APPEAL SUMMARY

Appeal ID: 27924	Project Address: 716 SE Grand Ave
Hearing Date: 8/3/22	Appellant Name: Tom Jaleski
Case No.: B-008	Appellant Phone: 971-238-5266
Appeal Type: Building	Plans Examiner/Inspector: Steve Mortensen
Project Type: commercial	Stories: 2 Occupancy: A, B, S-1 Construction Type: III-B
Building/Business Name: Literary Arts	Fire Sprinklers: Yes - Entire Building
Appeal Involves: Reconsideration of appeal	LUR or Permit Application No.:
Plan Submitted Option: pdf [File 1] [File 2] [File 3] [File 4] [File 5] [File 6] Proposed use: Commercial

LITERARY ARTS HQ

716 SE GRAND AVE, PORTLAND, OR 97232

ARCHITECTURAL SITE PLAN

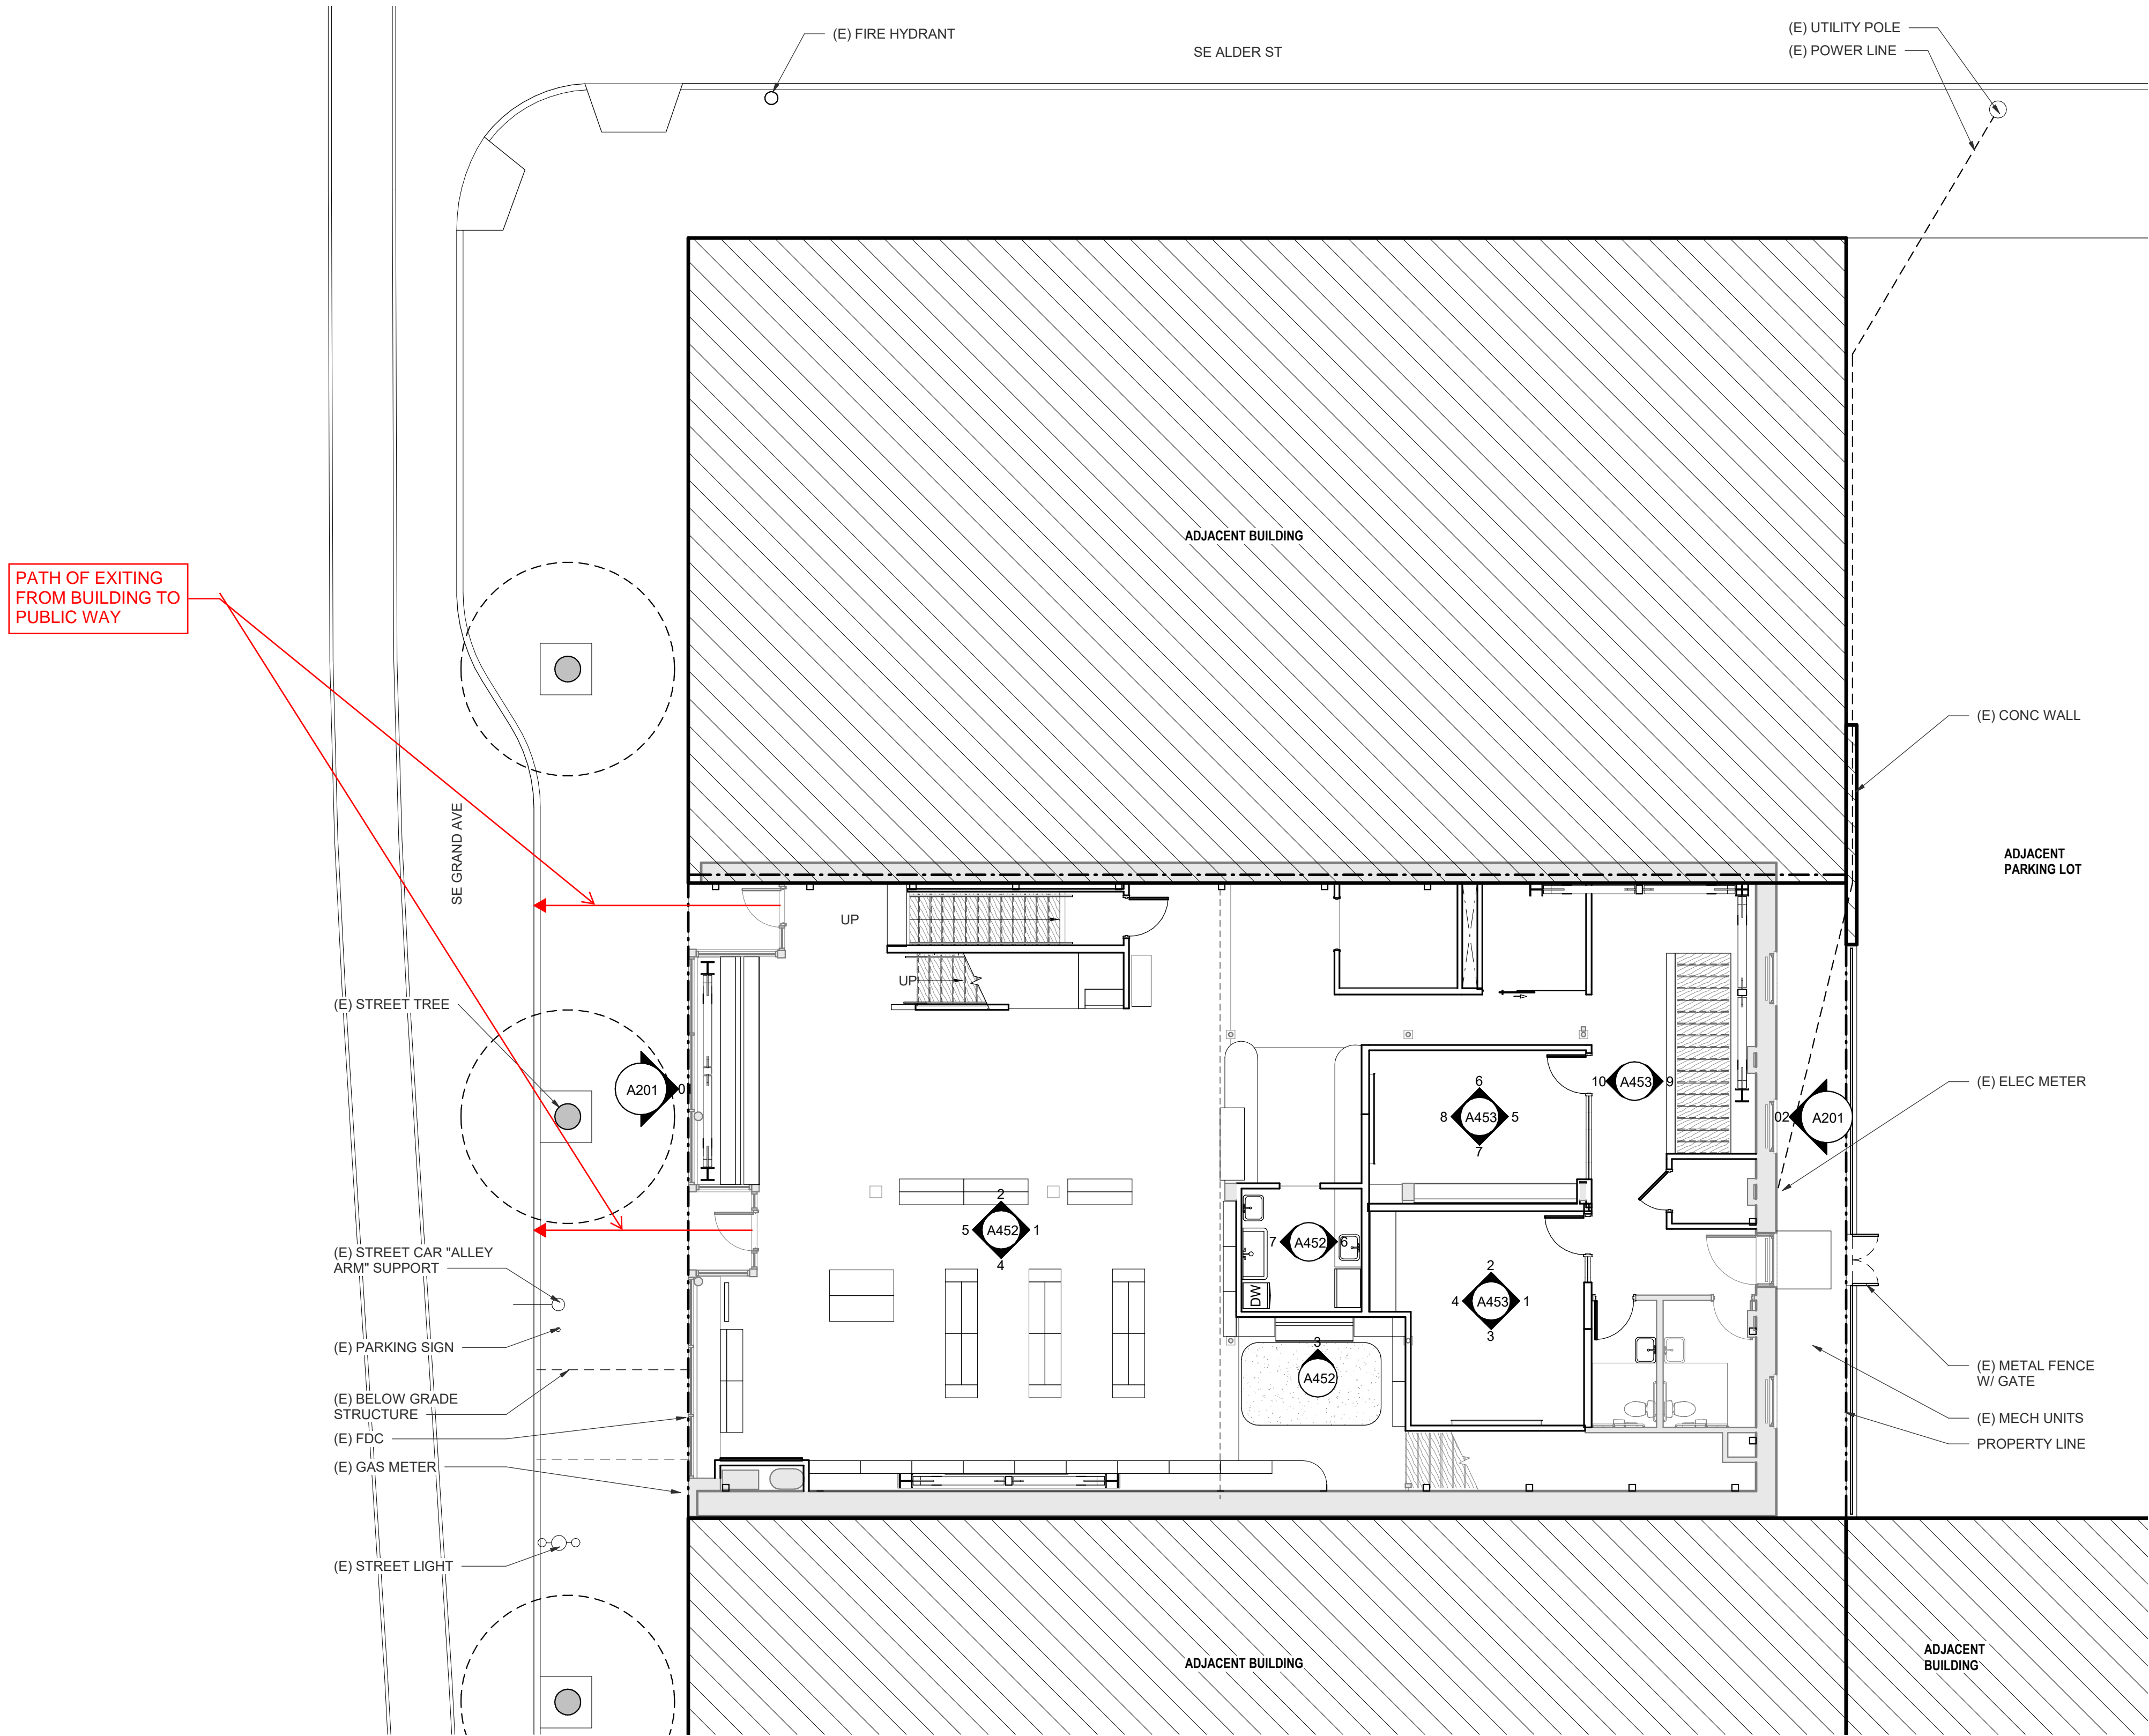
The project involves alteration of an existing historical building. Literary Arts, Inc. of Portland, Oregon, located in the historical Nathaniel West Building at 719 SE Grand Avenue in Portland, Oregon. This space was used previously as a furniture sales store and will be converted into office, storage and assembly spaces used for engagement of readers, support writings and inspire the next generation with great literature. The building currently has two exits in the front and one in the back. However, the back exit faces an existing parking lot without a path leading to a public way. That parking lot will get developed in the future and that exit will no longer be available for the occupants of this building. The two existing exits in the front are spaced less than 1/3rd the diagonal, but they are the only exits with access to public way. The diagonal dimension of the ground floor is 93'-4", which requires the two exits to be separated by a distance of 31'-1 1/3". The actual distance between the two exits is 28'-1".

It was noted in the BDS Early Assistance Response 12/08/2021 that primary characteristics of the Grand Avenue Historic District include center entrances and storefront predominantly at the street edge. Because of this, moving the main entry or adding a third exit door further south would not align with the historic character of the building or district overall. The separation distance is only deficient by three feet, which is only 10% less than the required separation distance. The proposal to upgrade the building systems, while optimizing and expanding the usefulness of the building will significantly improve safety and survivability of the occupants in case of fire or other life safety event.

- 1. Reduction in the minimum required plumbing fixture count: Granted as proposed.**
- 2. Increase in the maximum allowable area of a mezzanine from one third to one half of the space it is open to: Granted as proposed.**
- 3. Decrease in the minimum allowable exit separation distance from 31 feet, 1 inch to 28 feet, 1 inch: Granted as proposed.**

FLOOR PLAN - LEVEL 1

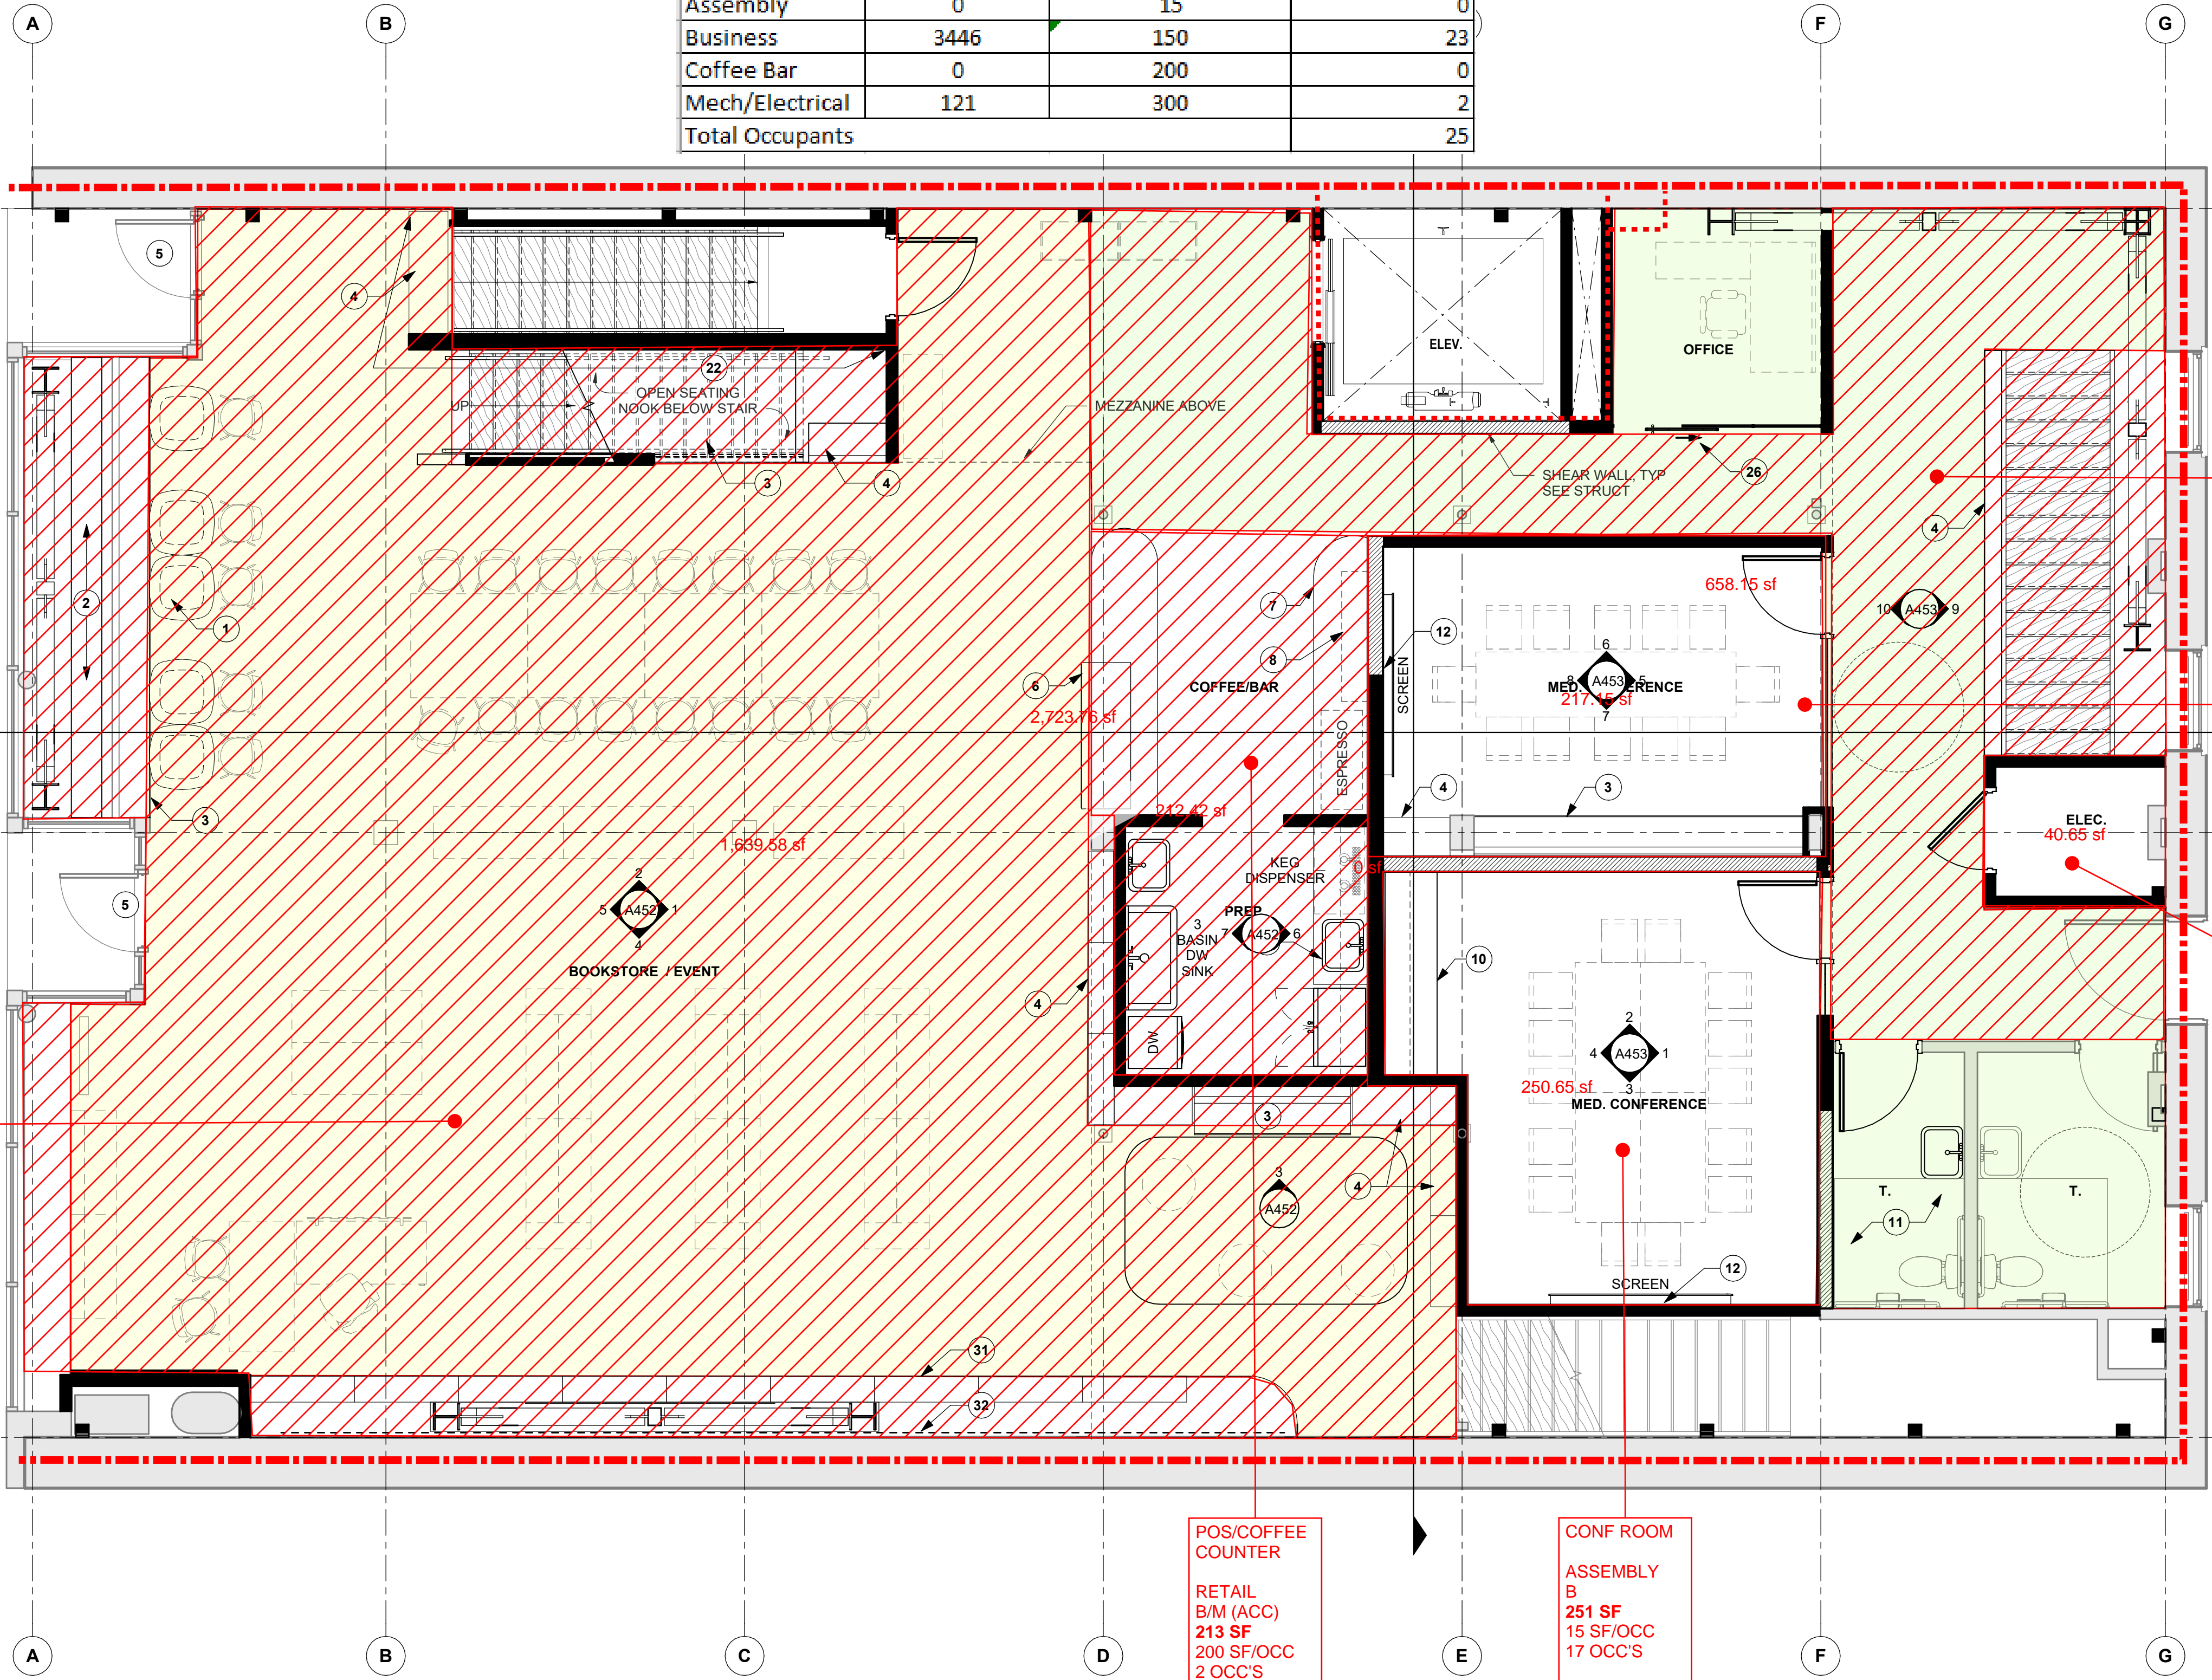
For the day-to-day operations of Literary Arts, the building will serve ultimately as a business type occupancy. As such, the plumbing fixture calculations for the conference rooms, which push the minimum required plumbing fixture counts higher than the existing plumbing fixtures are calculated for, lead to overcalculation based on the actual occupant load. All conference rooms are sized less than 750-square feet and are more closely associated with the business type occupancy that exists as the dominant occupancy of the building. With the plumbing fixtures calculated with these rooms at one occupant per 150 square feet as business occupancies, the minimum required

plumbing fixtures would be six water closets and six lavatories. The building would be compliant with the minimum required plumbing fixtures calculated this way. As these plumbing fixture calculations take potty parity into account, the fixture calculations also lead to overcalculation based on actual use. The restrooms provide an equality of fixture availability to all persons all genders equally. Since the restroom availability will be equal to all persons and genders, the historical situations where long lines of women waiting to use toilet facilities is not anticipated to be present as all restrooms will be available to all persons in the building. As such, the “potty parity” should be 1 to 1 for the building.
